TMSS Apparels Ltd.

66/3, Dhorpara, Sataish Chourasta, Tongi Gazipur.

1. Executive Summary

2. Observations

Observation-1: Design report doesn't comply with BNBC-2006 (Main Building).

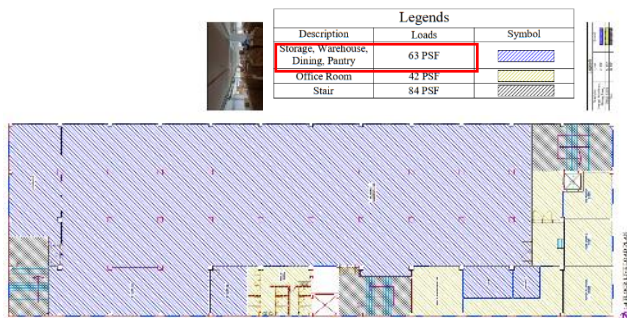
Description: The structure was constructed between March 2014 and completed in June 2017, but the design report is prepared as per NTPA guidelines. The building engineer is required to update the design report as per BNBC 2006.

Observation-3: Discrepancy in as-built drawing (Main Building).

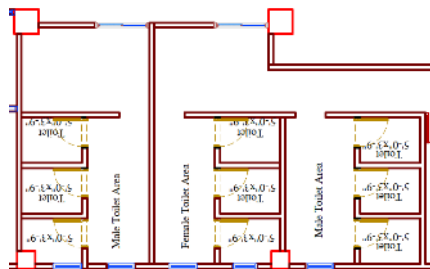
Floors build up not shown for toilet zone.

250mm floors build up found at toilet zone.

Description: 7 plastic water tanks (6–2000-litre, 1-1000 litre) were found on the roof slab which were not shown in as-built drawing. Also, 250mm floors were found at the toilet zone which was not shown in as-built drawing. The building engineer is required to update as-built drawing.

Observation-6: Column plaster damage due to trolley impact (Main Building).

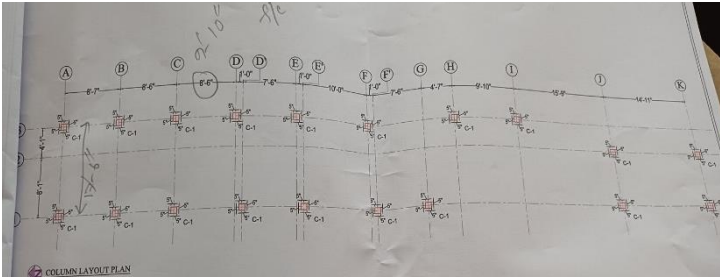
Description: Column plaster was found damaged due to trolley impact at several locations. The building engineer is required to repair the damaged areas and provide protection to avoid trolley impact.

Observation-8: Discrepancy in as-built drawing (Maintenance Building).

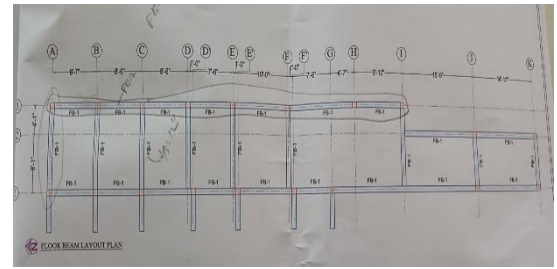
Mismatch in column grid spacing.

Mismatch in beam size.

Description: Mismatch in column grid spacing between on site and as built drawing. Also, two beam sizes were observed instead of one. The building engineer is required to survey the full structure and prepare accurate as-built drawing.

Observation-9: Discrepancy in as-built drawing (Security and RMS room).

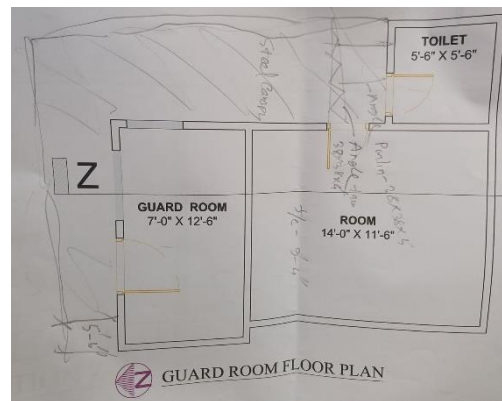
Steel Canopy is not shown in as built drawing.

Description: Lack of information was observed for Security and RMS room. Steel canopy is not shown in the layout. The building engineer is required to survey the full structure and prepare accurate as-built drawing.
